SERVICE BULLETIN

ALL LEGACY MODELS EQUIPPED WITH 4EAT

SUBJECT:**MANUAL VALVE STOPPER RETROFIT**

Figure 1

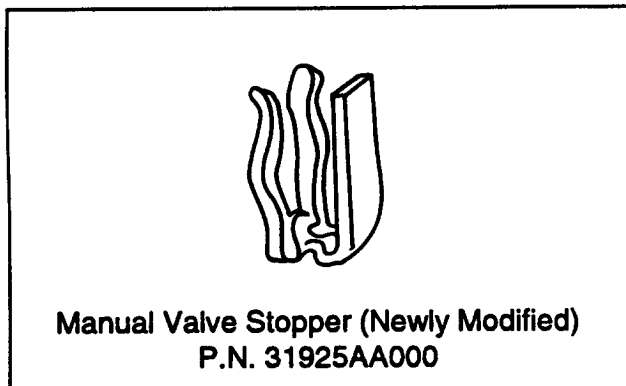
Should you encounter a 4EAT equipped Legacy that exhibits a resistance or possibly binds when shifting from manual 2 or 1 range, towards park position, a manual valve stopper or possibly a modified manual valve lever may need to be installed. These parts have been incorporated in production since 11/89, starting with Transmission Number 135220. See Figures 1 and 2 below.

Figure 3

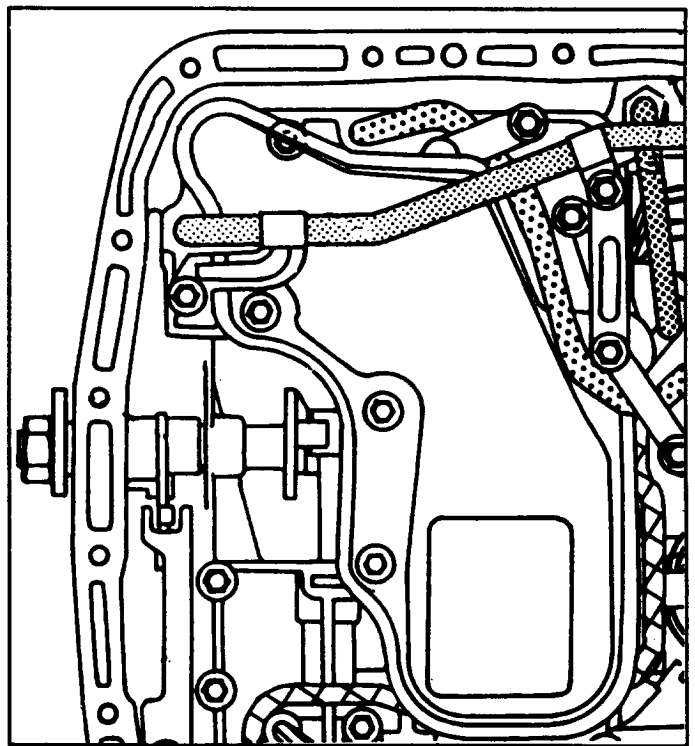
Bottom view of manual valve and lever after modification

Figure 4

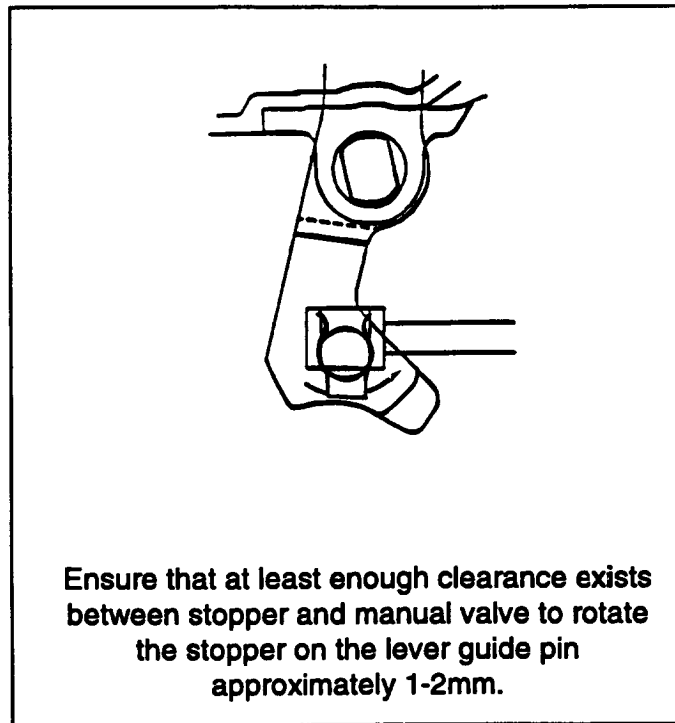
Checking Manual Valve Stopper Freeplay

NOTE: IF THERE IS NO PLAY BETWEEN STOPPER AND MANUAL VALVE, IT MAY CAUSE PREMATURE WEAR OR BINDING OF MANUAL VALVE.
